Duke Energy
Enclosure 4
Levy Nuclear Plant Units 1 and 2
COLA Revisions
(70 pages including cover page)

Associated LNP COL Application Revisions:

The following are the revisions to the LNP Units 1 and 2 COLA based on the changes presented in the previous enclosures. These revisions will be made in a future update of the LNP COLA.

Duke Energy Florida
Levy Nuclear Plant
Units 1 and 2
Part 2, Final Safety Analysis Report
Nuclear Island Non-Radioactive Ventilation
System Piping and Instrumentation Diagram
FIGURE 9.4-201

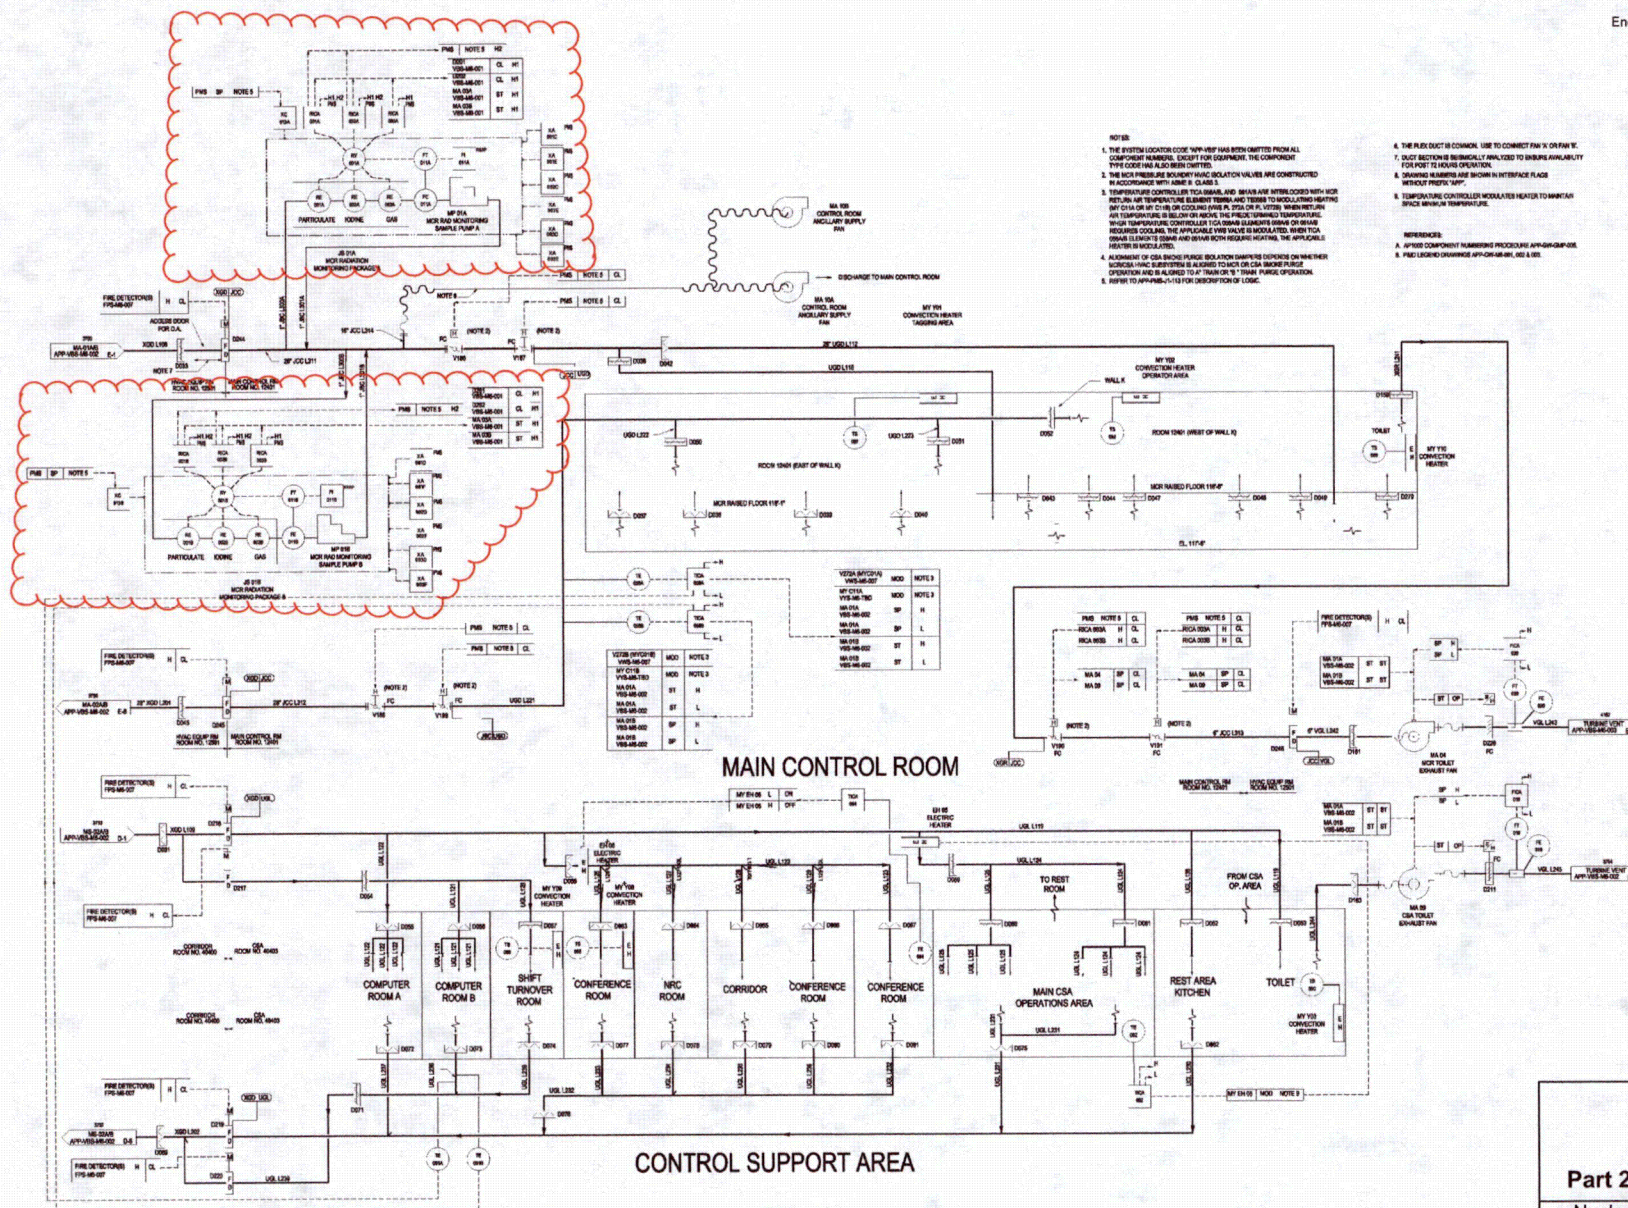
19. COLA Part 2 FSAR Chapter 9 will be revised to add a departure from DCD Figure 9.4.1-1 (Sheet 5 of 7), Nuclear Island Non-Radioactive Ventilation System Piping and Instrumentation Diagram, as new FSAR Figure 9.4-201, with a LMA of LNP DEP 6.4-1. This figure will also be added to the list of figures from Chapter 9. Figure 9.4-201 is shown below:

Figure 15.4-201

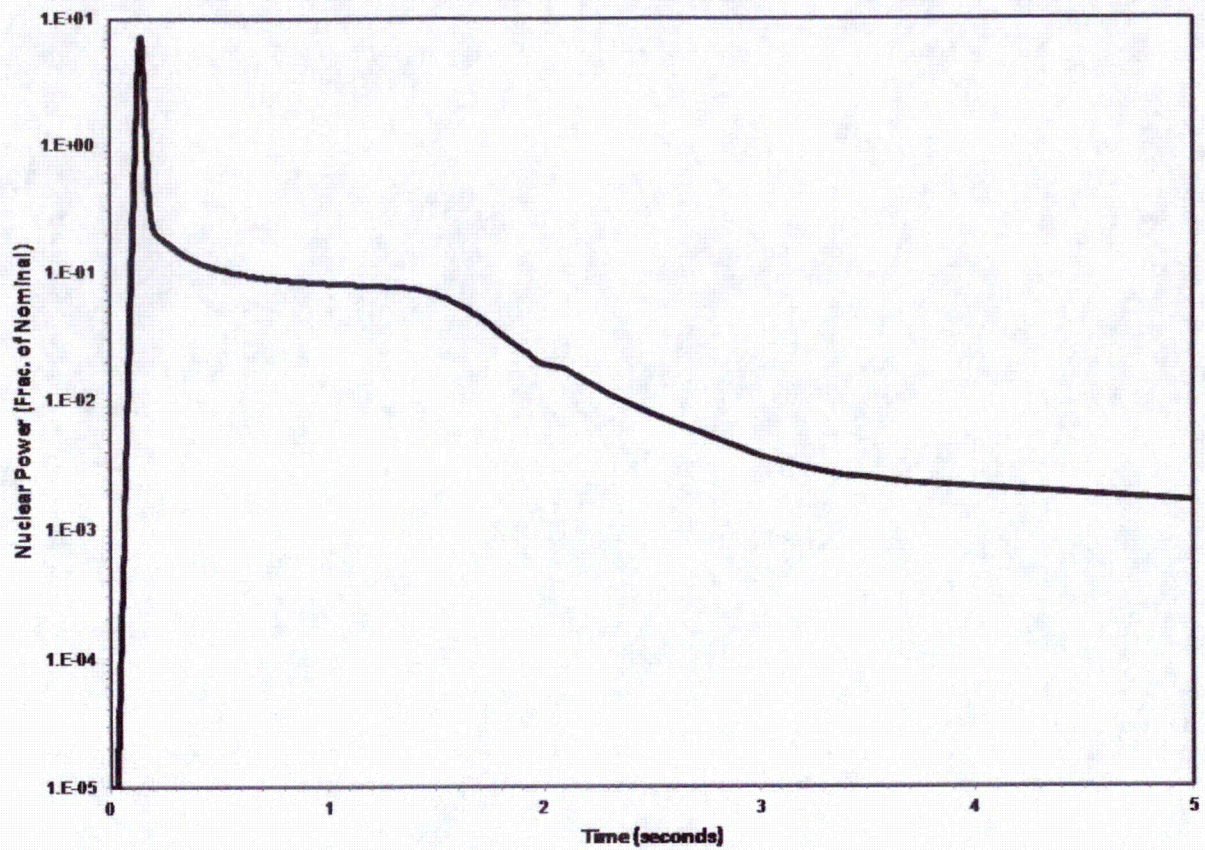
62. COLA Part 2 FSAR Chapter 15 will be revised to add a departure from DCD Figure 15.4.8-1, Nuclear Power Transient Versus Time at Beginning of Life, Full Power, as new FSAR Figure 15.4-201, Nuclear Power Transient Versus Time for the PCMI Rod Ejection Accident, with a LMA of LNP DEP 6.4-1. This figure will also be added to the list of figures from Chapter 15. Figure 15.4-201 is shown below:

Figure 15.4 -202

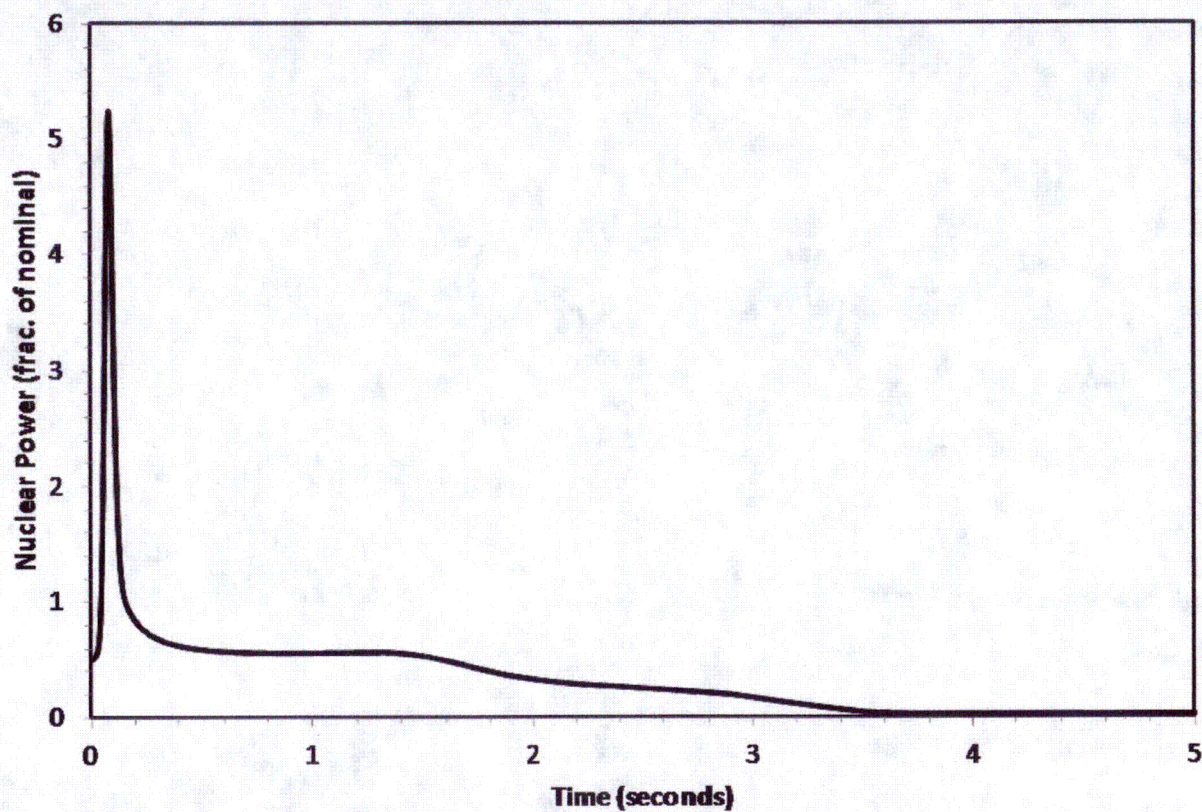
63. COLA Part 2 FSAR Chapter 15 will be revised to add a departure from DCD Figure 15.4.8-2, Hot Spot Fuel, Average Fuel, and Outer Cladding Temperature Versus Time at Beginning of Life, Full Power, as new FSAR Figure 15.4-202, Nuclear Power Transient Versus Time for the High Cladding Temperature Rod Ejection Accident, with a LMA of LNP DEP 6.4-1. This figure will also be added to the list of figures from Chapter 15. Figure 15.4-202 is shown below:

Figure 15.4-203

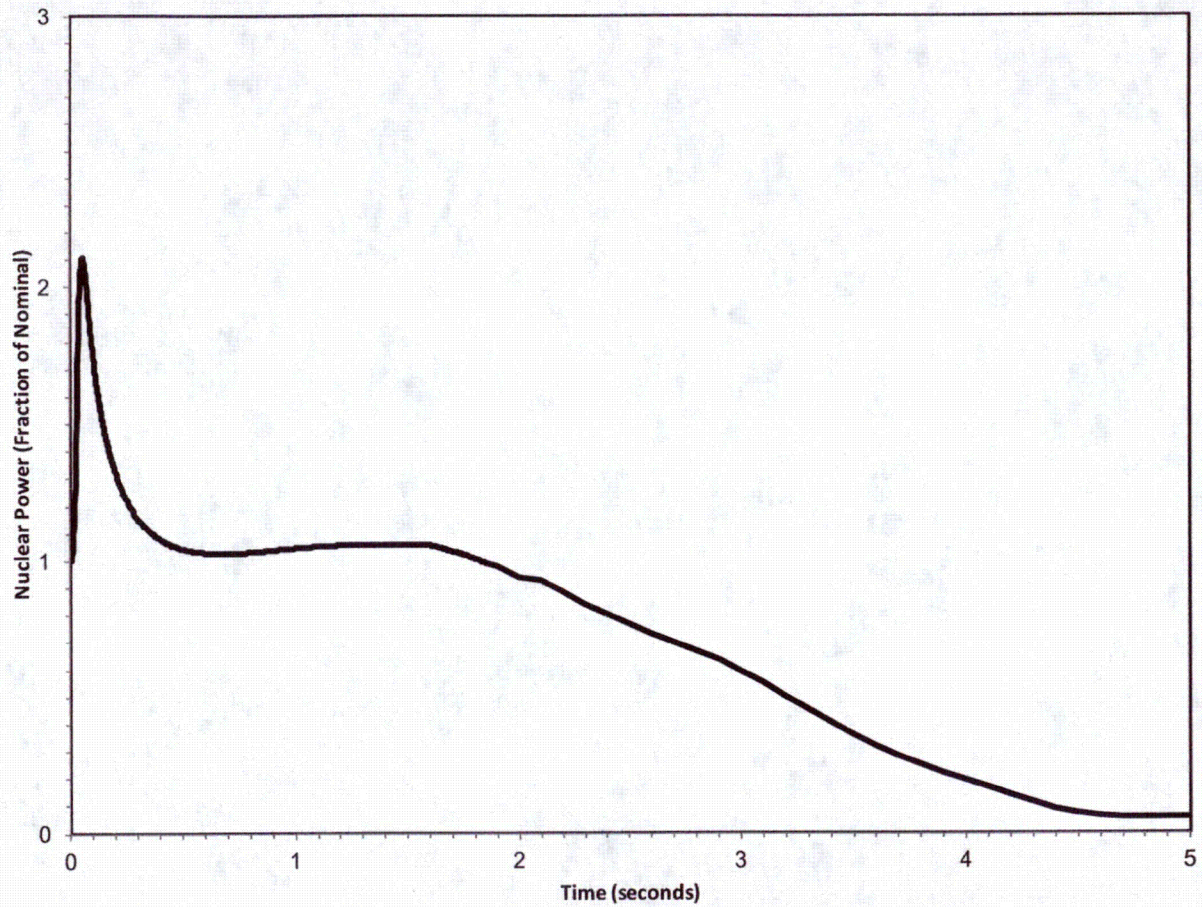
64. COLA Part 2 FSAR Chapter 15 will be revised to add a departure from DCD Figure 15.4.8-3, Nuclear Power Transient Versus Time at End of Life, Zero Power, as new FSAR Figure 15.4-203, Nuclear Power Transient Versus Time for the Peak Enthalpy and Fuel Centerline Temperature Rod Ejection Accident, with a LMA of LNP DEP 6.4-1. This figure will also be added to the list of figures from Chapter 15. Figure 15.4-203 is shown below:
